### **Written submission from CNSC Staff**

**Ontario Power Generation Inc.**

Applicability of the Darlington New Nuclear Project environmental assessment and plant parameter envelope to selected reactor technology

## **DNNP Workshop Summary Report**

Figure 2.1.1-2: Darlington Nuclear Generation Station and Darlington New Nuclear Project Lands

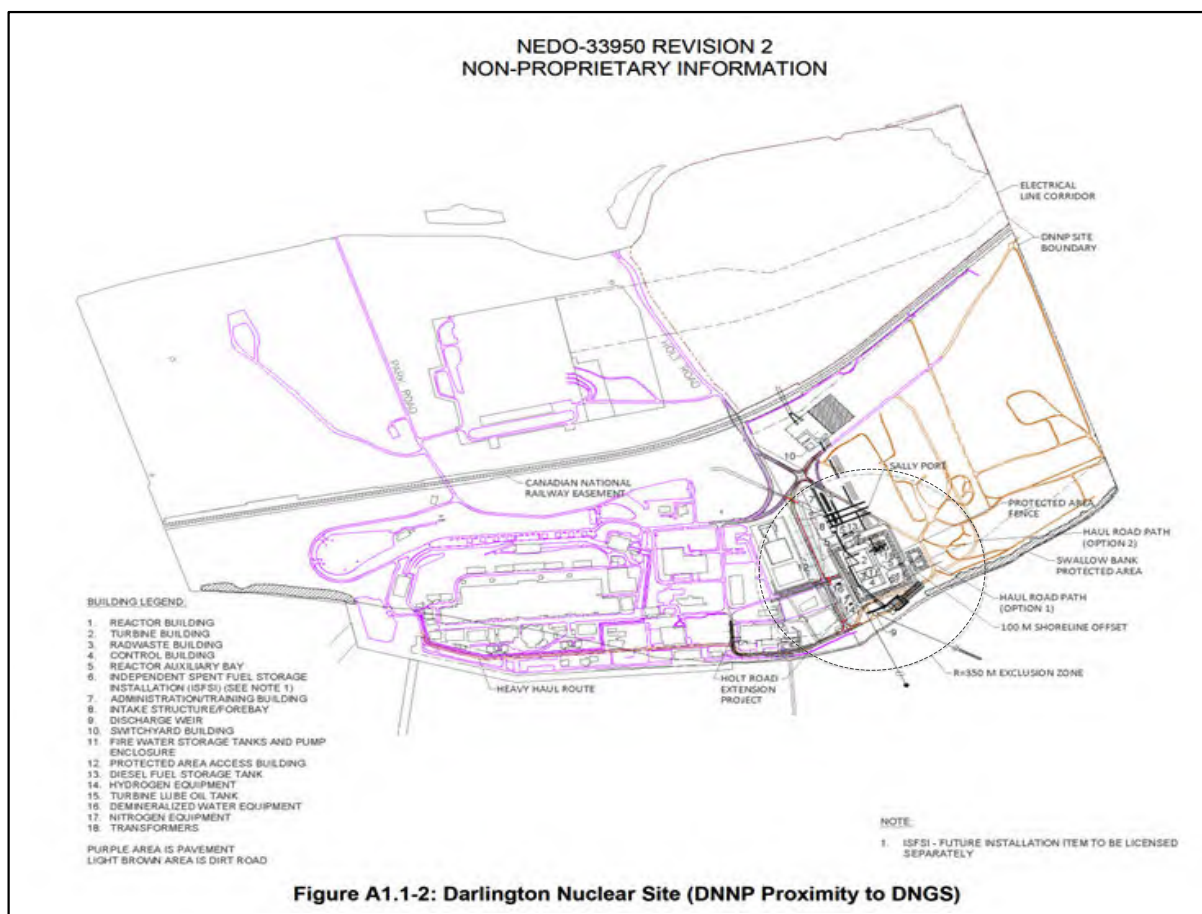
In each of these two diagrams, green circles represent the boundary of the exclusion zone.

In the aftermath of the Fukushima triple meltdown of 2011, we have a better understanding of the dangers of co-locating reactors. It is perhaps a blessing in disguise that DNGS B never got built. Be that as it may, OPG and CNSC are now considering up to 4 new reactors of the BWRX-300 variety to fit into this rather crowded space, with spent fuel dry storage facilities now occupying some of the space originally intended for DGNS B.

It appears that the first BWRX-300 will be right inside the redrawn DNGS exclusion zone, Its own exclusion zone (circle below, radius 350 m) largely overlaps the one from DNGS.

Figure A1.4-2: DNNP Switchyard Site Plan

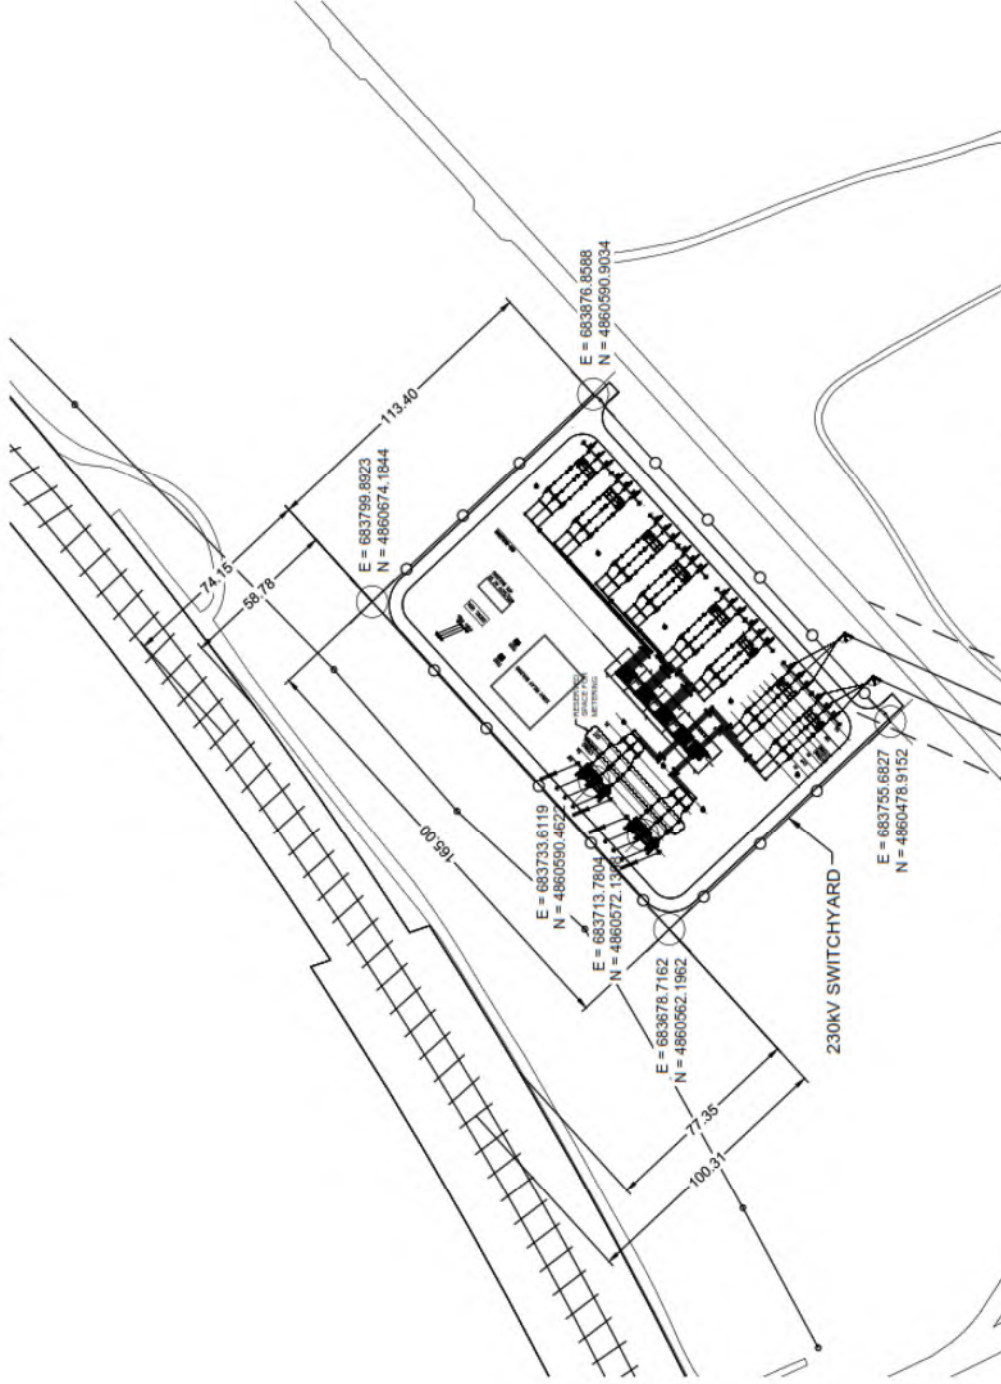
Figure 7: BWRX- switchyard is 58 meters from railway line. My house is at a greater distance from a line and shakes when trains go by relatively slowly.

**Figure 11: Darlington reactor vault allows no release path for any hydrogen produced in a core damage accident**

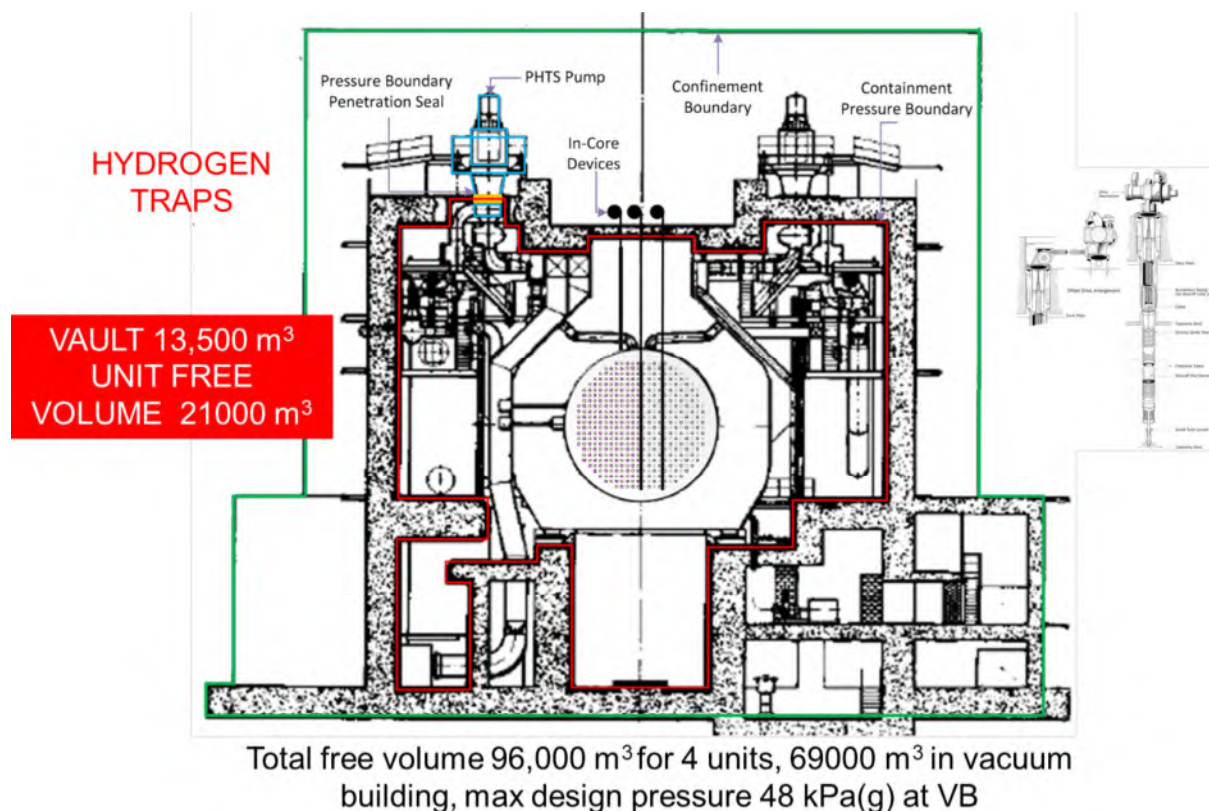
Explosion of hydrogen in a Darlington containment in early stages of a severe core damage accident is of a great probability because there is little pathway for it's escape from the congested top of the inverted-cup shaped reactor vault where it will accumulate and escapes to, in an accident which we fondly call Limited Core Damage Accident a LOCA with a Loss of ECC. In a severe core damage accident whose hydrogen production will be 10 times more than the 65 kmole that the industry has claimed. No matter what the total amount of hydrogen produced, an accumulation above 4% by volume in air will start a fire and above 8% an explosion. That means a Fukushima like ending. We also point out that Darlington does not have a containment to speak of, once the vacuum building has spent itself. Top of the reactivity decks is an industrial building roof.

**Figure 13 : Lower than core placement of pressurizer that will drain boiler tube inventory at Darlington/Bruce reactors in SBO**

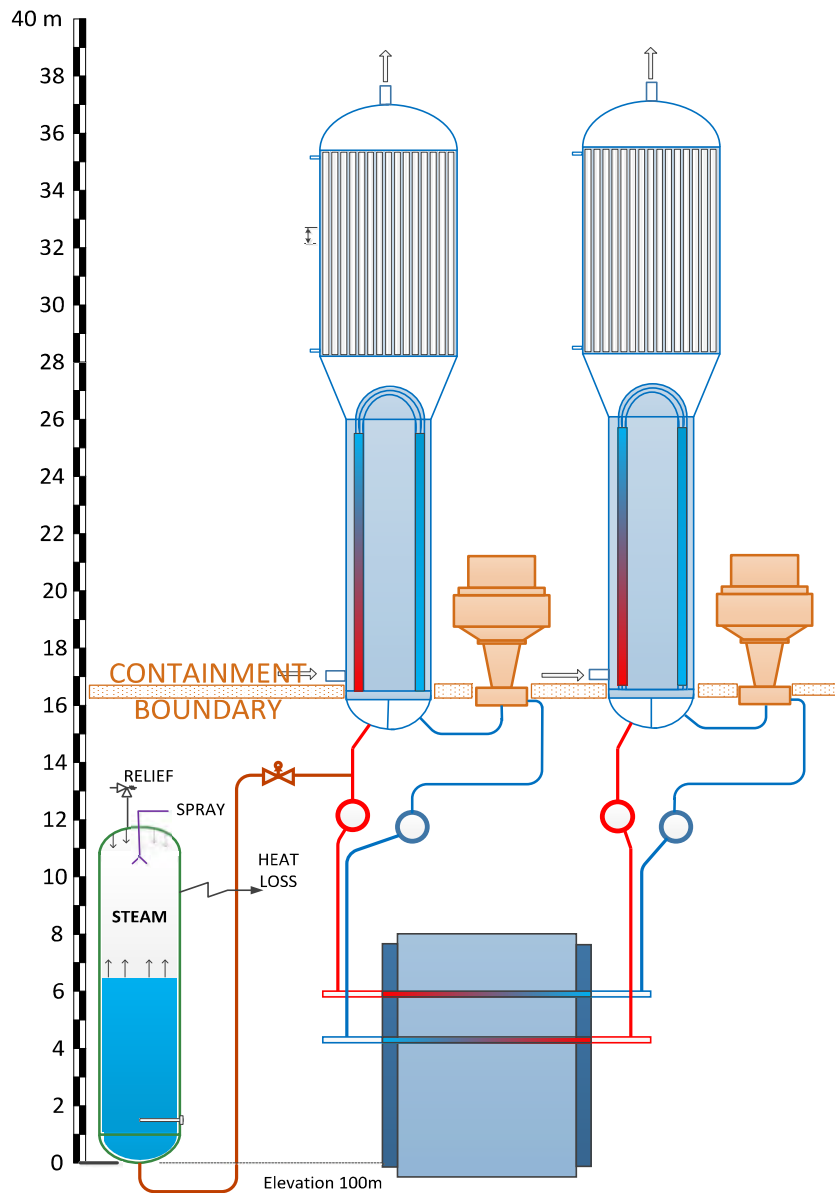
The strange choice of pressurizer location below the boilers and reactor will cause draining into it of primary coolant from boiler tubes in a SBO to an extent that boilers will become useless as heat sinks and no amount of emergency measures to add water to boilers will restore cooling to the reactor core unless the primary cooling system was replenished as well, something that cannot be done after an SBO in the present design and presently configured SAMGs.

Figure 14 : Sample results of operational releases of Tritium from US BWRs in 2008 from reference xx and PPE data for BWRX-300,

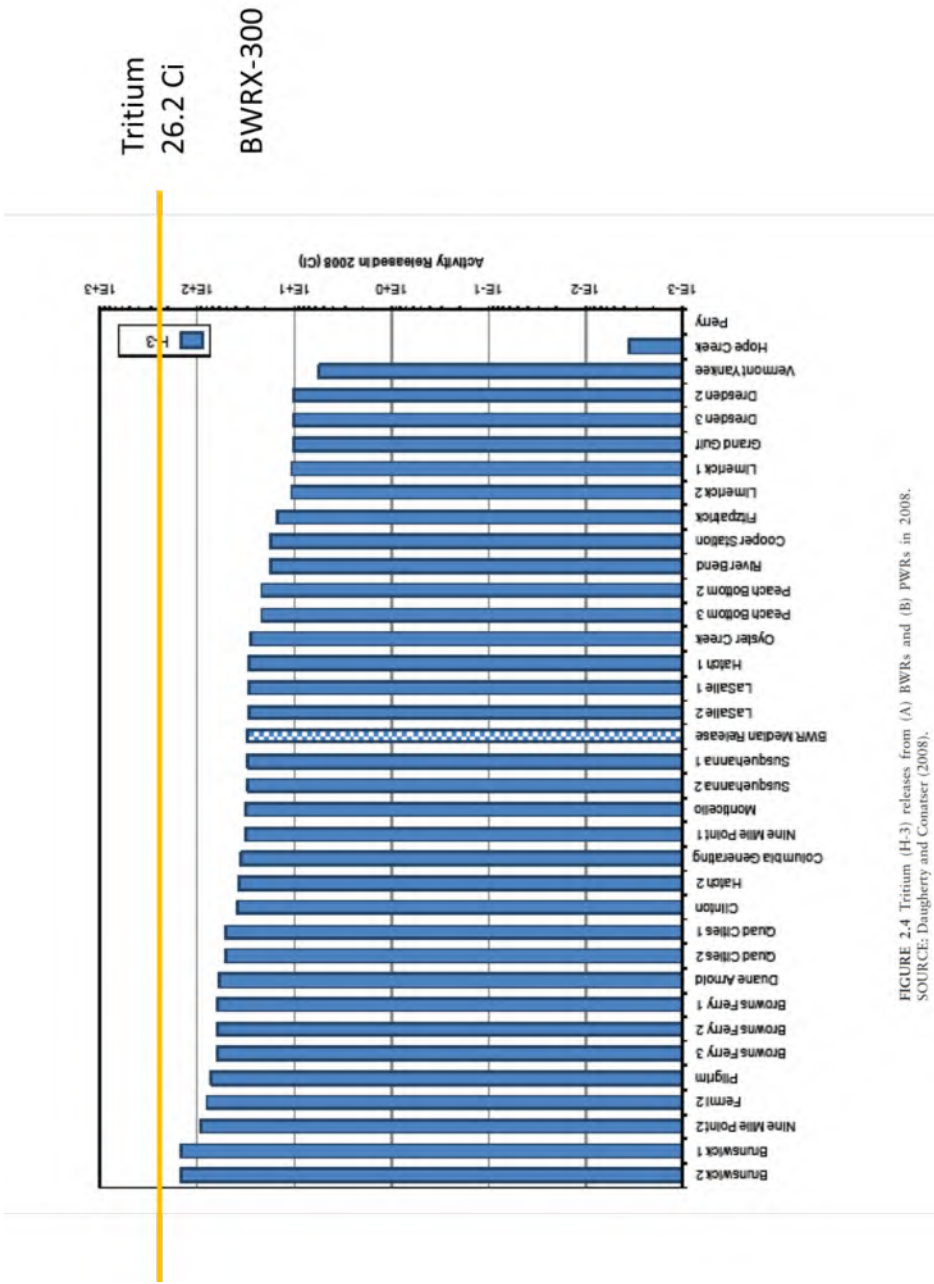
We propose that the current PPE be not accepted as surrogate to anything and a renewed set of documents be prepared that details the actual data for BWRX-300 and issued for comments to me. It should include enough information on each of the reactor designs that were considered ( as a summary design description with pictures and tables and references) and a much broader discussion of the chosen BWRX-300 design.

Figure 1 : Lower than core placement of pressurizer that will drain boiler tube inventory at Darlington/Bruce reactors in SBO

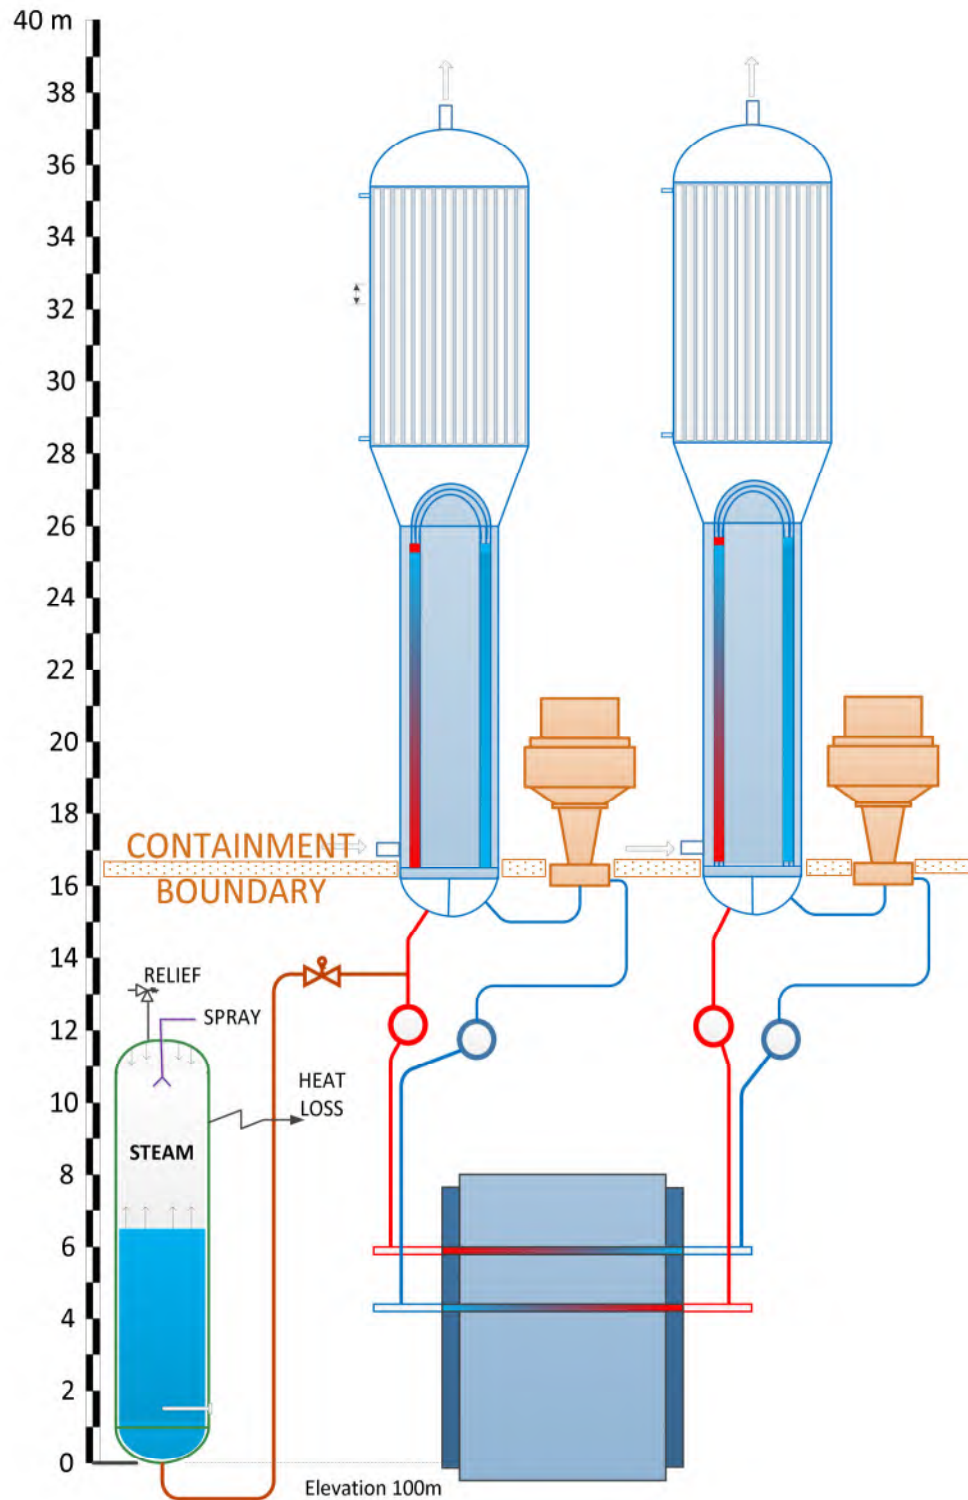
What is fundamentally disturbing is that certain long well known design features that may cause an unwarranted pressure boundary failure (*because the primary heat transport system (PHTS) overpressure steam relief capacity is too low*) or accelerate onset of core disassembly (*such as an un-necessary, forced expulsion by flashing of a critical amount of moderator upon onset of boiling because rupture disks actuate instead of a controlled relief through relief valves*) or a lack means of direct depressurization of PHTS or cause the containment to leak profusely at relatively low pressures have not been accepted or rectified. Certain challenges to the containment integrity, such as from high amounts of hydrogen and deuterium produced by oxidation of outside and inside surfaces of feeders after a core damage accident of LOCA+LOECC have been ignored for even design basis accidents without the regulator ever highlighting the omission or recognizing that Carbon steel is more oxidation reactive than Zircaloy at all temperatures.

Figure 11 : Building basement layout below Lake water level. The emergency power supply generators are at grade level with cable tunnel 6m under.

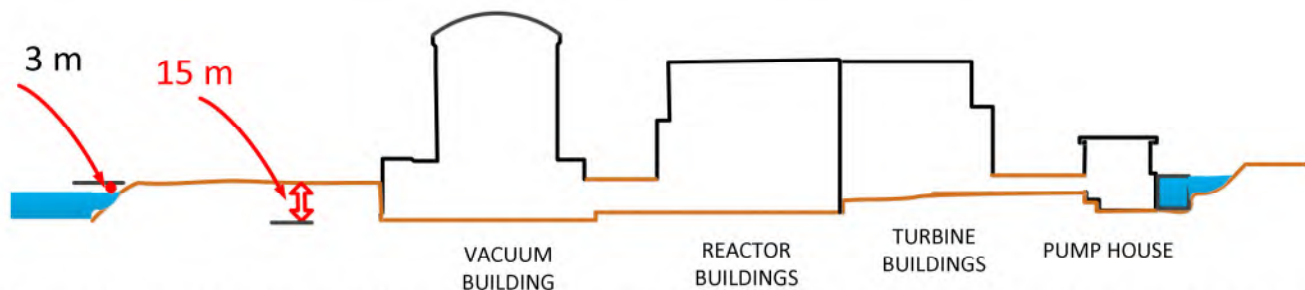
The basement of the reactor buildings (fuelling machine duct and the pressure relief duct) is located below the level of the water in the lake. To the credit of the utilities, new portable Emergency Diesel Generators have been to be located at elevations higher than the original backup Diesel Generators that are at lower grade elevations, about 3m higher than the water, not dissimilar to what sank Fukushima. They are yet to be relocated to higher elevations. If that was done a failure similar to that at Fukushima could be avoided.
